Staff Report: Poplar Pointe, Site Plan No. 820200020

Completed: 12/9/2019

Description

Figure 4: Proposed Site Plan

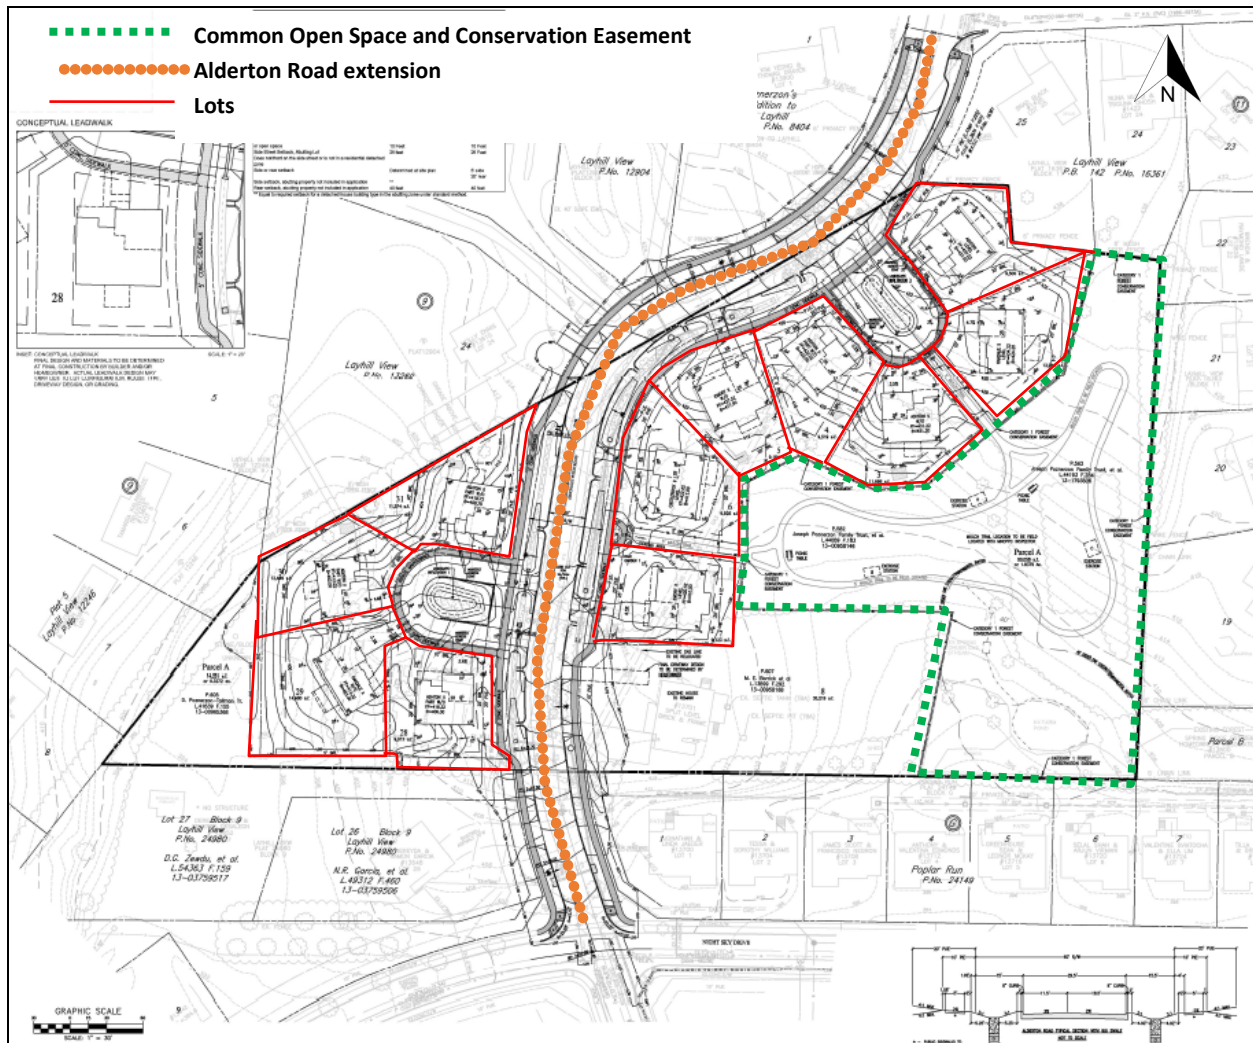
1. Please coordinate with MNCPPC about the updated classification of Alderton Road and how it impacts the road cross section, ROW, horizontal curve radii and sight distance. Update the plan accordingly.
2. Proposed street trees species and spacing depend on the followings; please address and update the plan accordingly:
 - a. presence of utility poles and OH wires along the site frontage.
 - b. final driveway layout for 13701 Alderton Road (P. 607).
3. Provide curb radius where existing and proposed Alderton Road connect.

Figure 6 – Proposed Curb Ramp Improvements at Alderton Road and Night Sky Drive

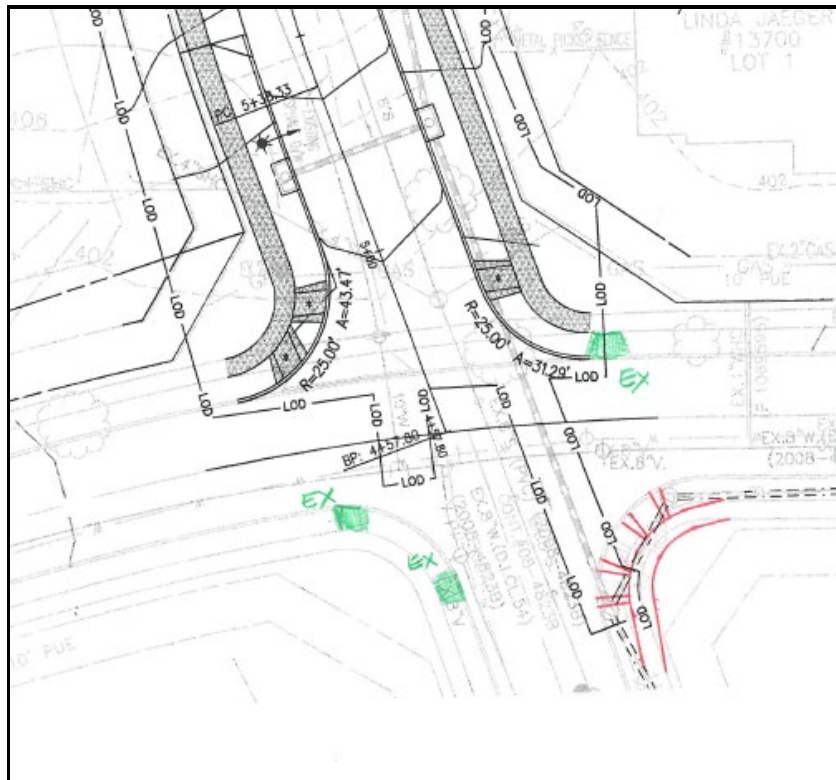
Currently, the proposed Site Plan also includes the relocation of existing ADA curb ramps and new crosswalks. However, additional re-positioning of the ADA curb ramps is necessary. As conditioned, prior to plan certification, the Applicant must provide dual ramps aligned with the existing receiving ramps at the southeast corner of the intersection of Alderton Road and Night Sky Drive. As a result, acceptable ADA ramps must be at all four corners at the intersection of Alderton Road and Night Sky Drive to facilitate safe pedestrian crossing movements. Any relocated ADA ramps must be located as close as practical to the intersection and all receiving ramps must be properly aligned. The provision of adequate sidewalks and crosswalks will assist in facilitating access to bus service, open space within the Subject Site, and to other nearby community amenities. The proposed sidewalks along each of the circular driveways are included in the PIE, and the easement delineation must be clearly depicted on the final plan for certification. Figure 6 depicts an acceptable curb ramp alignment at Alderton Road and Night Sky Drive, which the Applicant has agreed to provide.

- v. Provide dual ramps aligned with the existing receiving ramps at the southeast corner of the intersection of Alderton Road and Night Sky Drive.
 - vi. Construct the final driveway layout of the existing home to remain at 13701 Alderton Road (Parcel 607) as determined by the homeowner.

1. We recommend the applicant provide dual ramps aligned with the existing receiving ramps at the SE corner of the intersection of Alderton Road and Night Sky Drive.
